Form 3160-5 (June 2019)	UNITED STATES DEPARTMENT OF THE INTERIOR BUREAU OF LAND MANAGEMENT	FORM APPROVED OMB No. 1004-0137 Expires: October 31, 2021
SUNDRY NOTICES AND REPORTS ON WELLS <i>Do not use this form for proposals to drill or to re-enter an abandoned well. Use Form 3160-3 (APD) for such proposals.</i>		5. Lease Serial No. NMNM0438001
		6. If Indian, Allottee or Tribe Name

EOG respectfully requests an amendment to our approved APD for this well to reflect the following changes:

Deep Elem 4 Fed Com 502H (FKA 802H) API #: 30-015-54085

Revised Wellbore

WELL LOCATION AND ACREAGE DEDICATION PLAT

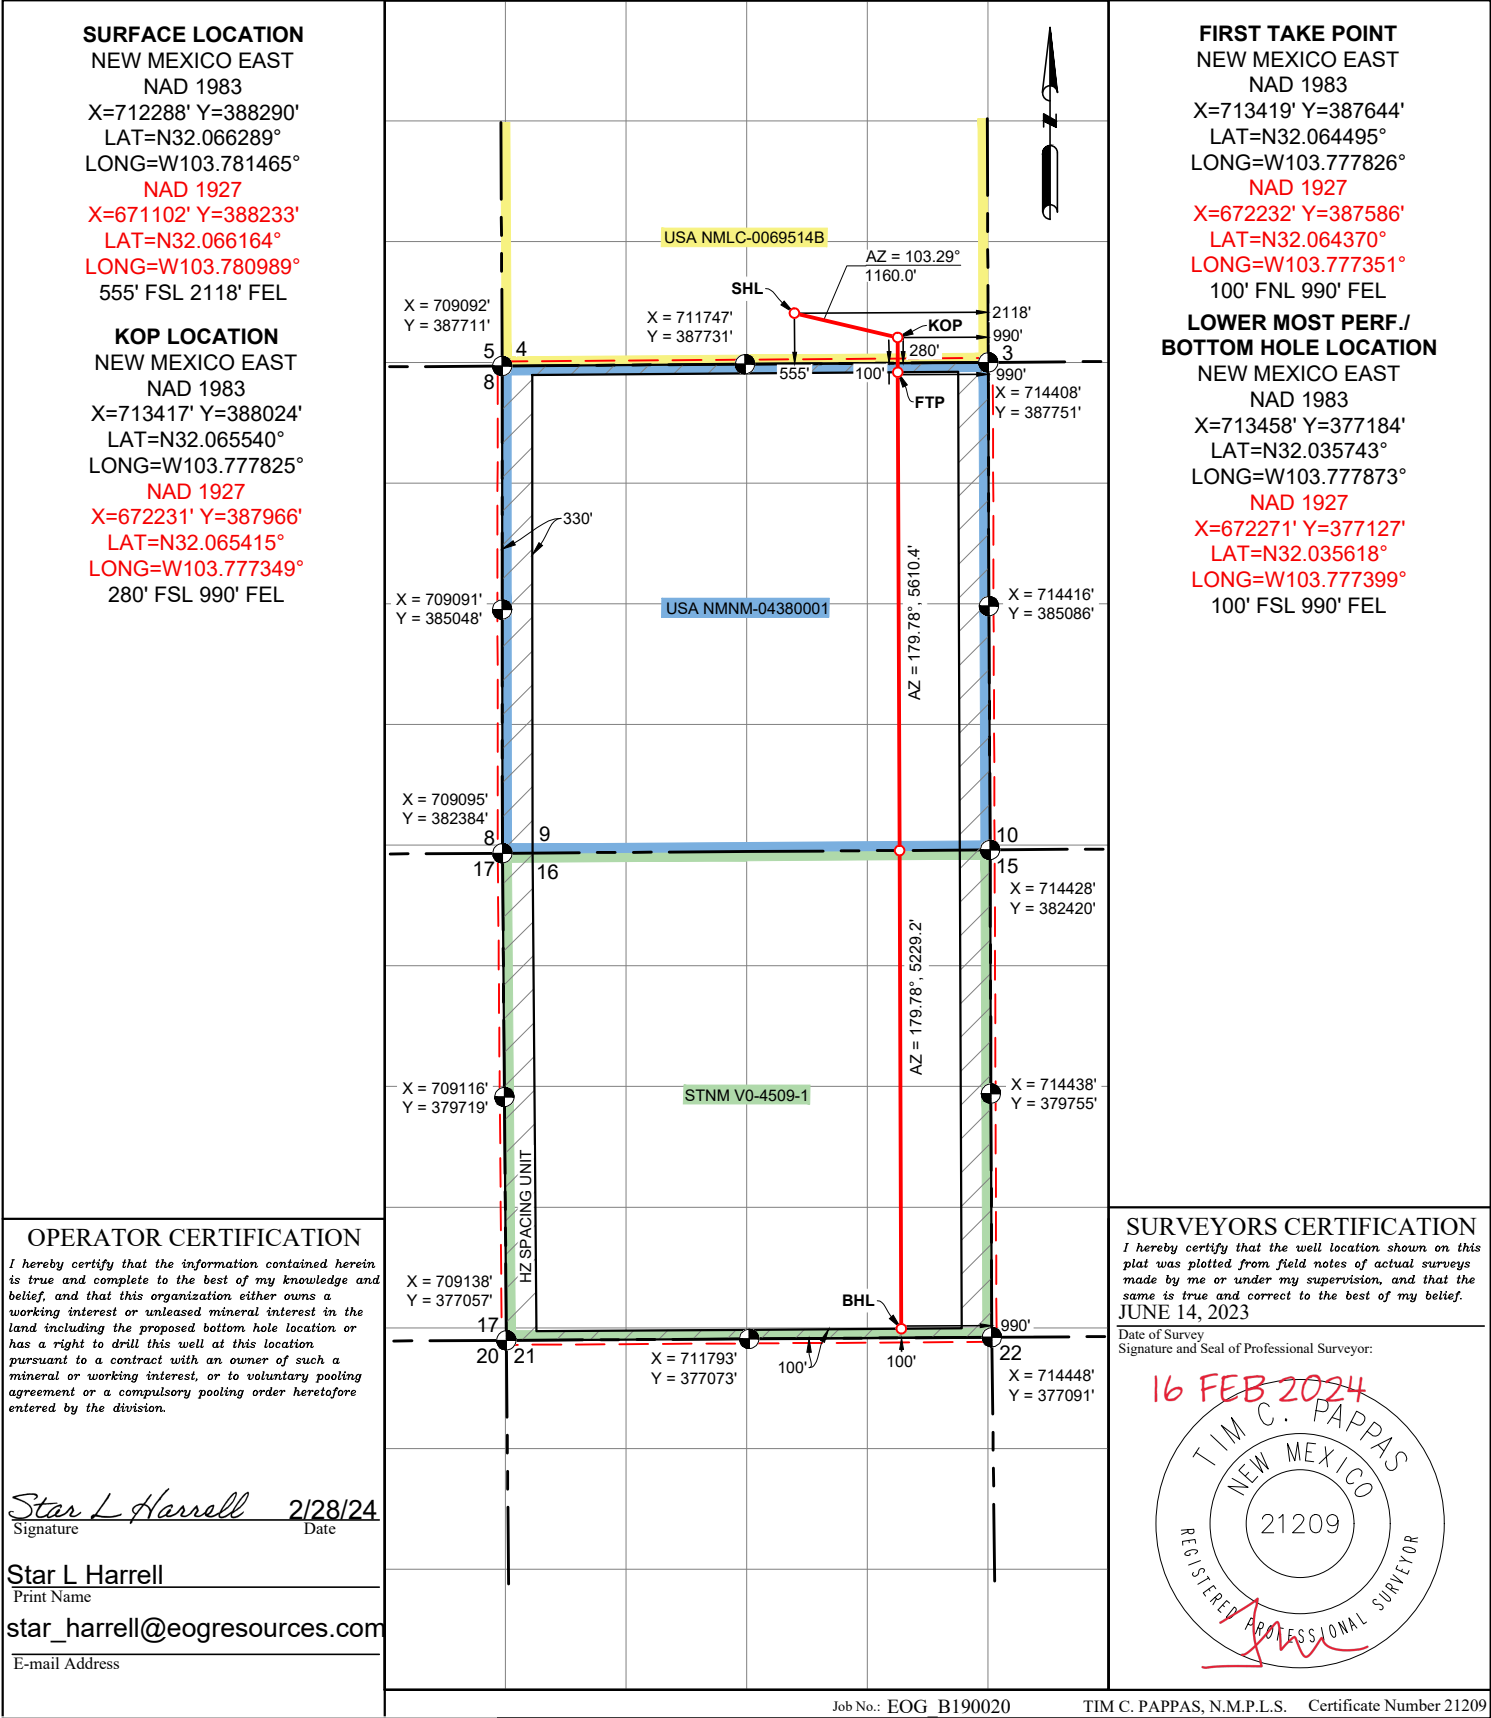
Change name from Deep Elem 4 Fed Com 802H to Deep Elem 4 Fed Com 502H.

Change BHL from T-26-S, R-31-E, Sec 16, 230' FSL, 1650' FEL, Eddy Co., NM, to T-26-S, R-31-E, Sec 16, 100' FSL, 990' FEL, Eddy Co., N.M.

UL or lot no.	Section	Township	Range	Lot Idn	Feet from the	North/South line	Feet from the	East/West line	County
P	16	26 S	31 E		100	SOUTH	990	EAST	EDDY

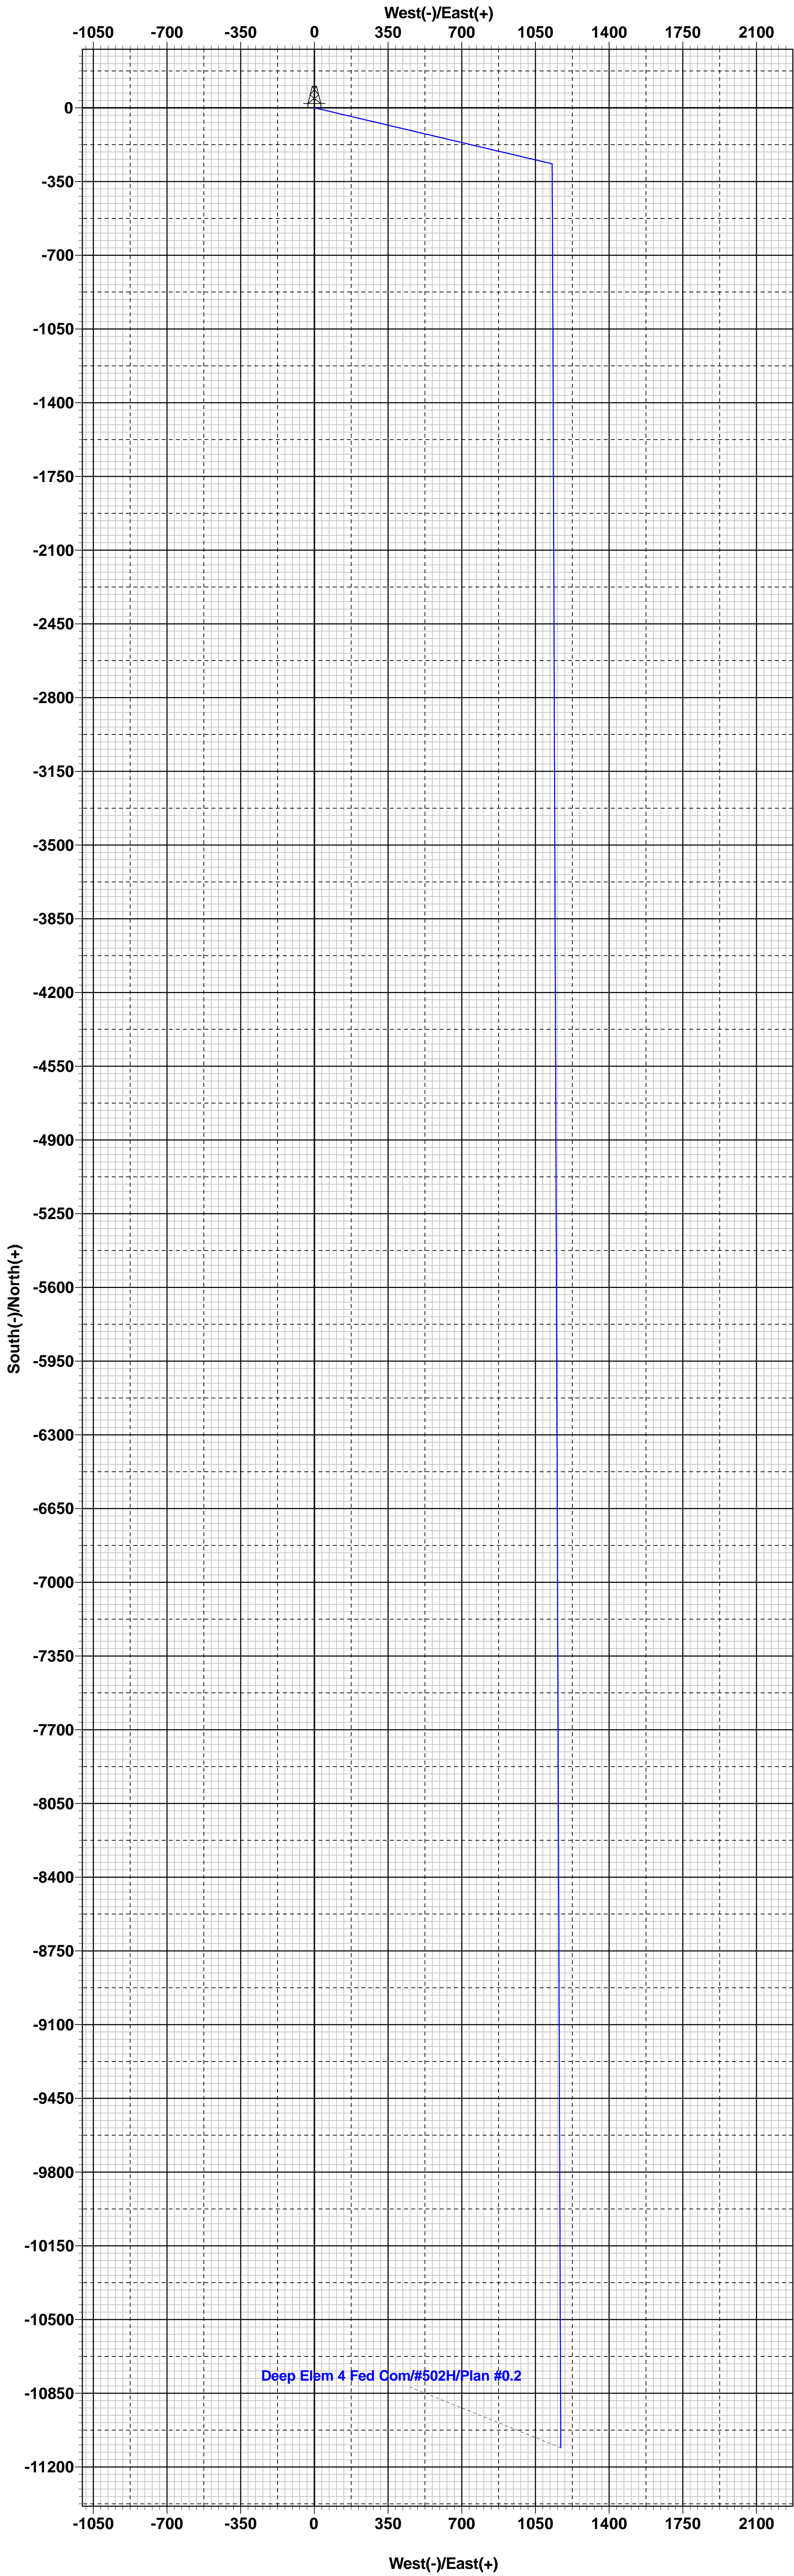
Update casing and cement program to current design. Batch #277328

Bit Size: 16"
13-3/8", 54.5#, J-55, STC
@ 0' - 1,240'

Bit Size: 11"
9-5/8", 40.#, J-55, LTC
@ 0' - 3,830'

Bit Size: 6-3/4"
5-1/2", 20.#, P110-EC, DWC/C IS MS
@ 0' - 20,736'

Lateral: 20,736' MD, 9,949' TVD
Upper Most Perf:
100' FNL & 990' FEL Sec. 4
Lower Most Perf:
100' FSL & 990' FEL Sec. 16
BH Location: 100' FSL & 990'
FEL
Sec. 16
T-26-S R-31-E

KOP: 9,620' MD, 10,620' TVD
EOC: 10,374' MD, 11,098' TVD
